## Machine Service Bulletin No. 430

LA-5 and LA-6

Automatic Division Shift Cam Movement

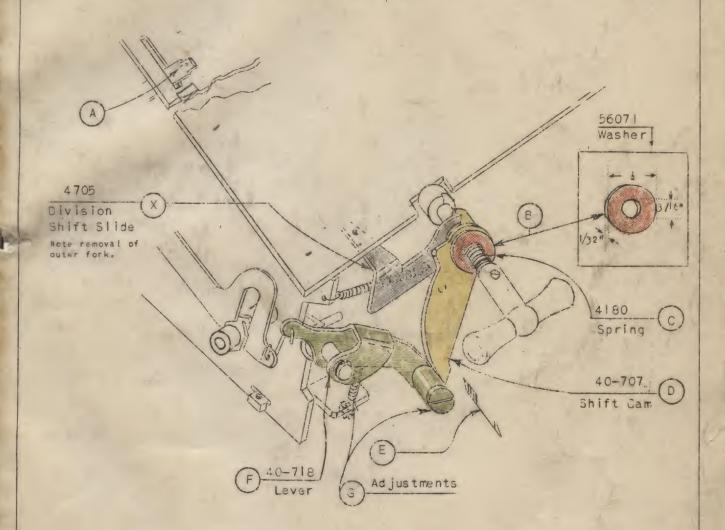
A 56071 spacing washer (B) is being installed in current LA-5 and LA-6 machines between the 40-707 shift cam (D) and the 4180 spring (C) to eliminate the possibility of (D) moving too far in the direction of arrow (E) when the division lever (A) and 4705 slide (X) are automatically restored to neutral position.

It is important that the 40-718 lever (F) and 40-707 shift cam (D) are properly adjusted at (G) and aligned in relation to each other.
